810/12 HIGH RD:
PROP REAR EAST ELEVATION

810/12 HIGH RD:
PROP SECTION AA LOOKING NORTH

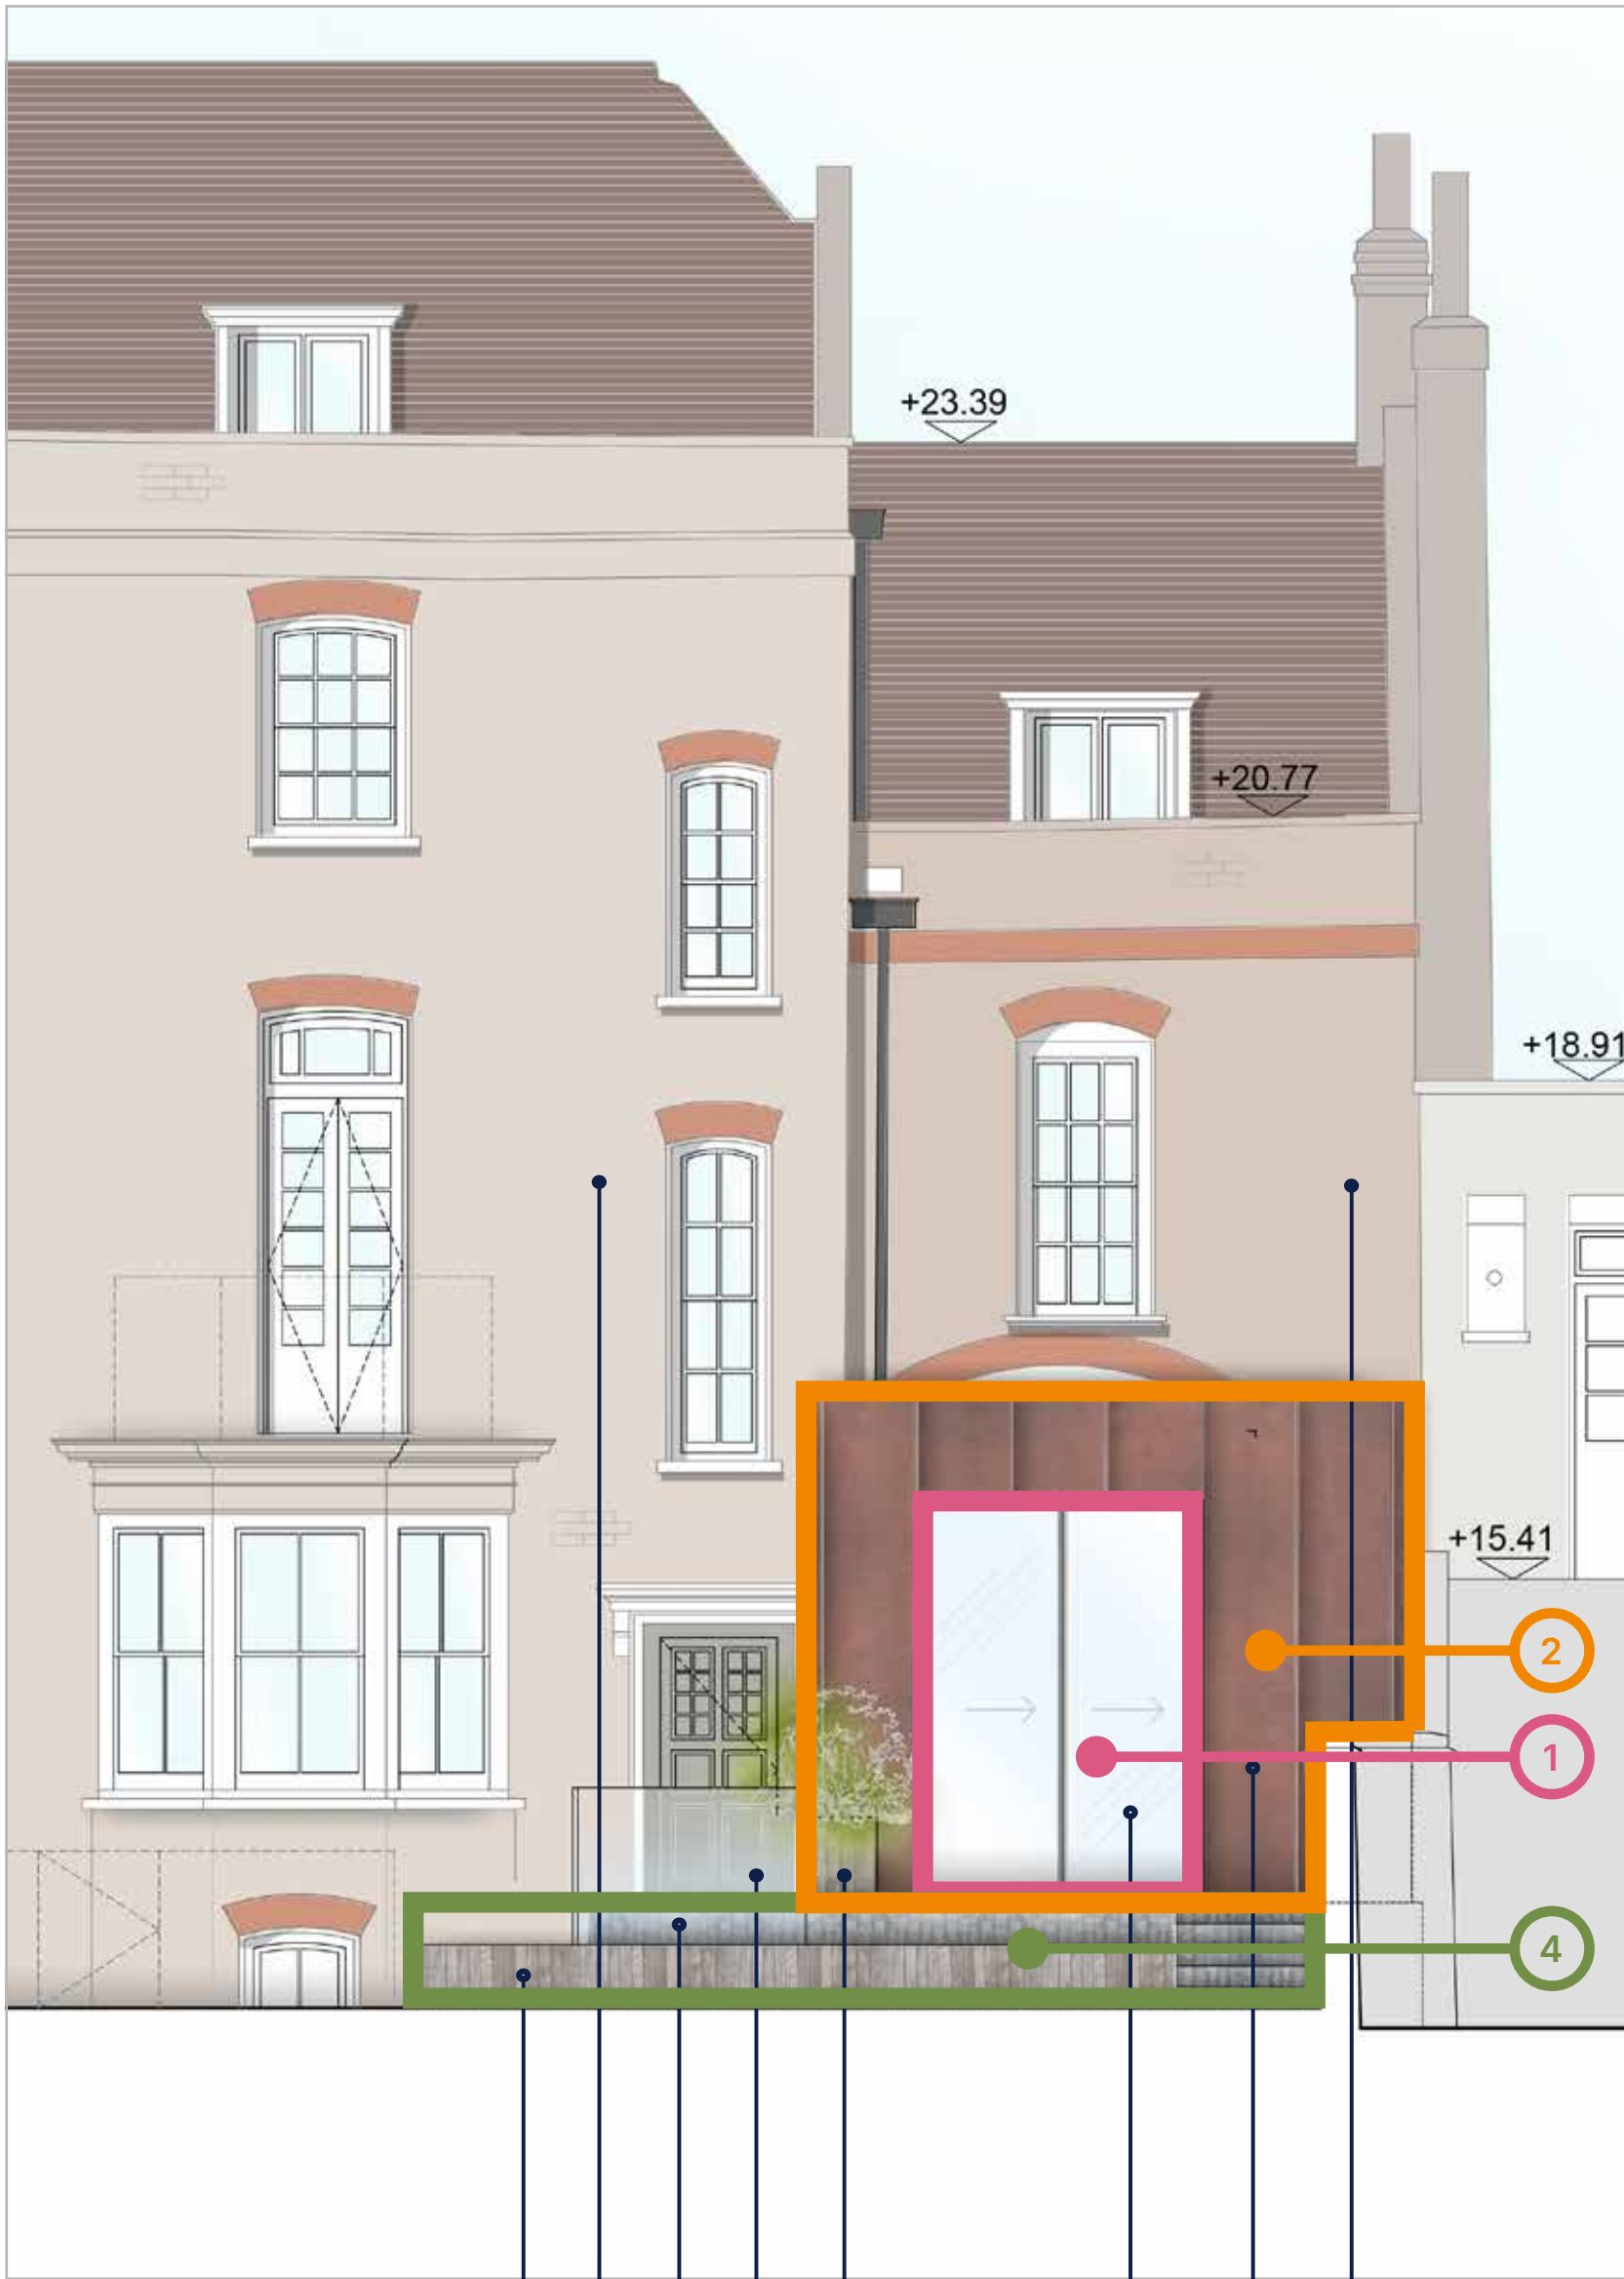
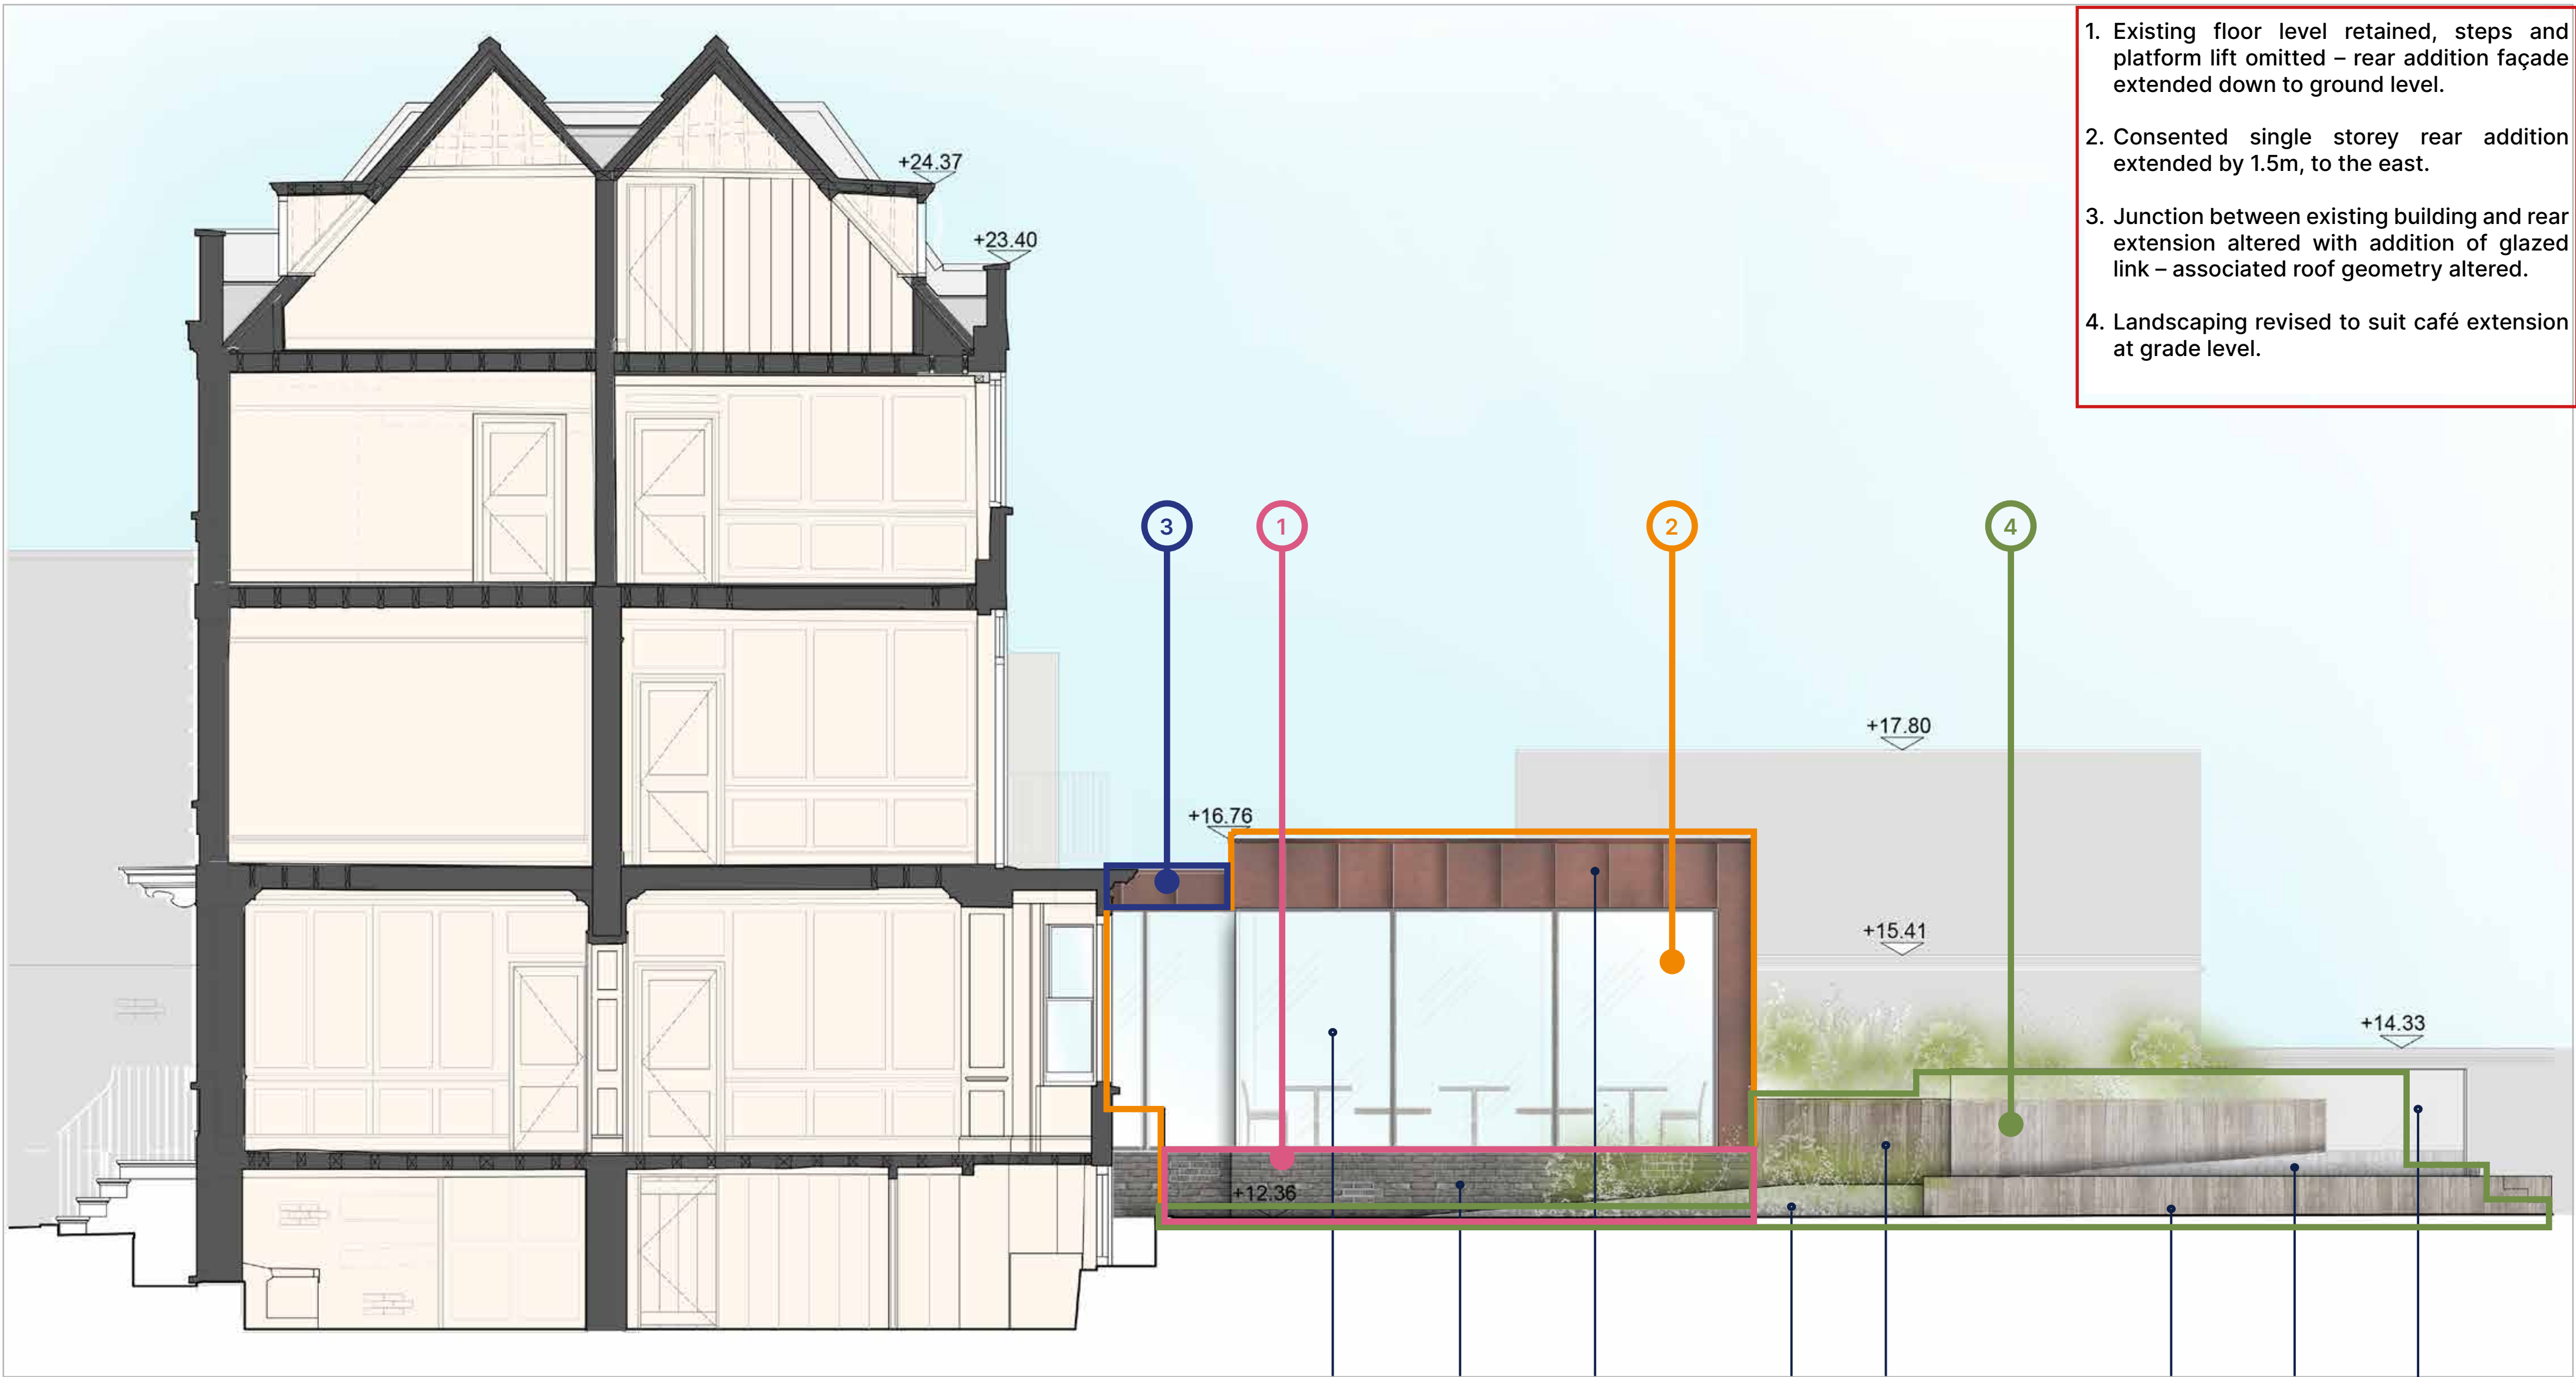
1. Existing floor level retained, steps and platform lift omitted – rear addition façade extended down to ground level.
2. Consented single storey rear addition extended by 1.5m, to the east.
3. Junction between existing building and rear extension altered with addition of glazed link – associated roof geometry altered.
4. Landscaping revised to suit café extension at grade level.
